APPROVED MEETING MINUTES
July 2, 2015

Northgate Station Garage

Phase
Schematic Design

Figure 2. *Site plan for the north entry plaza from the October 2014 (above) and July 2015 presentations.*

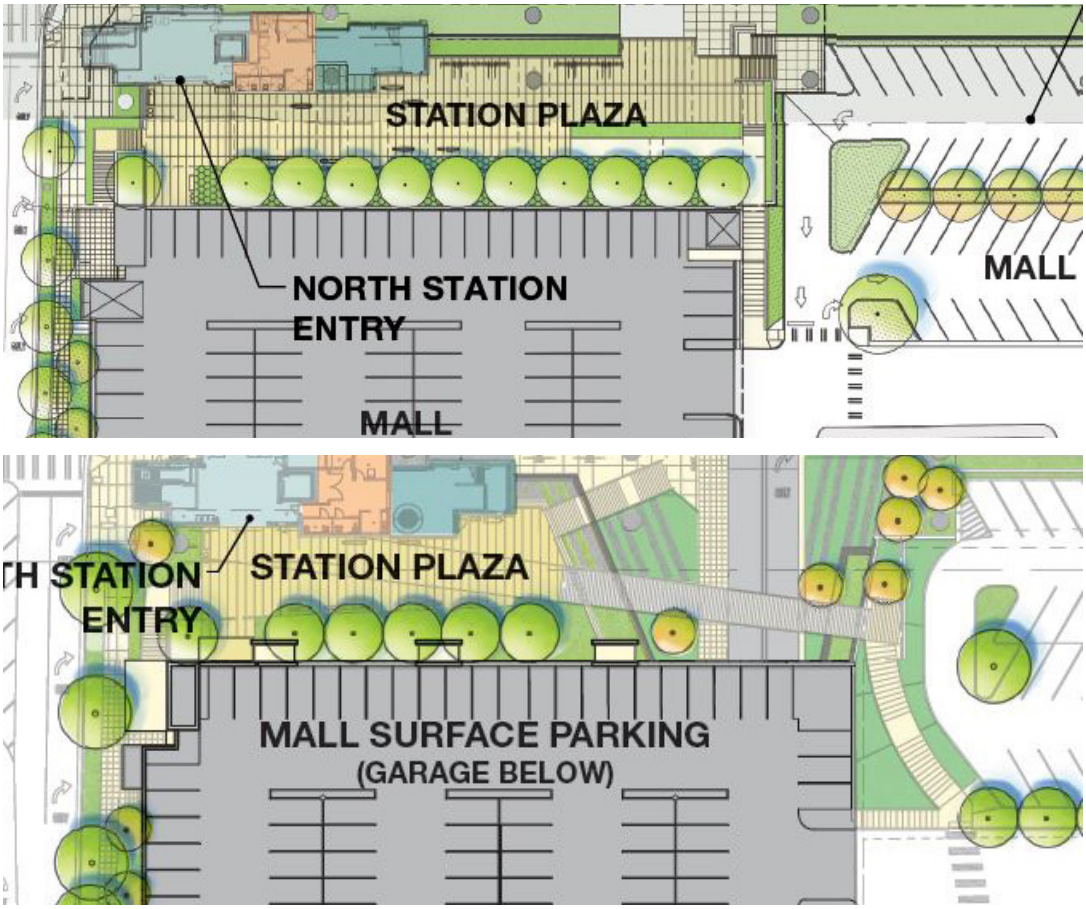
Summary of Discussion
The LRRP first discussed the plaza and pedestrian circulation at the north entry plaza given the substantial design changes since the LRRP's concept design approval. The LRRP supported the decision to redesign the northern portion of the plaza and the addition of the pedestrian bridge, which Panel members found to be an exciting element of the design. LRRP encouraged the team to make the bridge design as light and transparent as possible to make it distinct from the garage and north plaza. The LRRP also recommended further exploration of whether the stair at the south end of the plaza could move to the west to create a more generous and welcoming landing space at NE 103rd Street adjacent to the elevator.

Figure 3. *The proposed pedestrian bridge over the garage entrance is visible in this west elevation.*

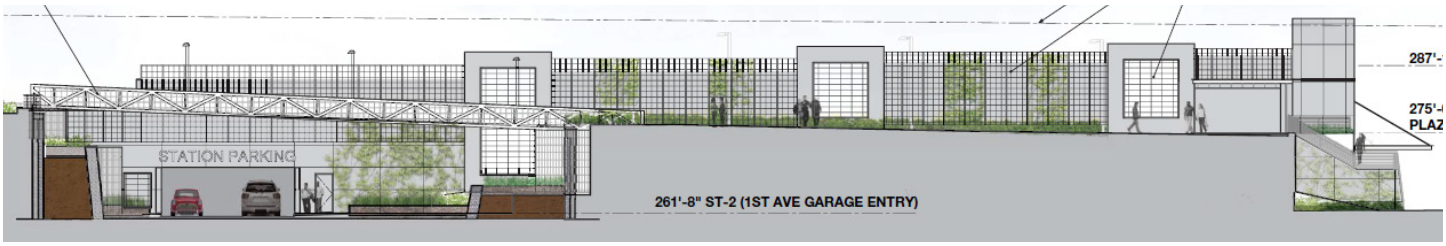
3. Design the pedestrian bridge to appear light and transparent.
4. Incorporate methods to slow vehicles entering and exiting the garage along 1st Avenue NE, including visual and/or tactile ground-plane treatments.

Figure 5. The LRRP suggested further study of this crosswalk in order to create a safe and legible pedestrian experience

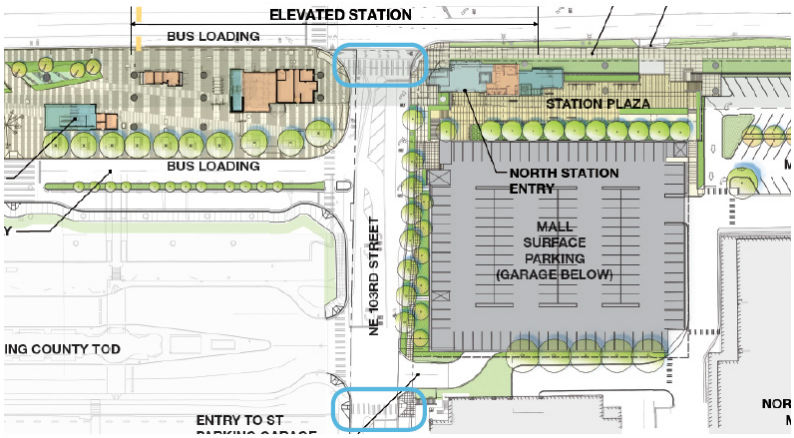
1. Consider moving the south stair to the west to expand the landing space at NE 103rd St adjacent to the elevator (**Figure 4**).
2. Continue to study whether the crosswalk along NE 103rd Street, shown **in Figure 5**, should be perpendicular to the sidewalk rather than angled.
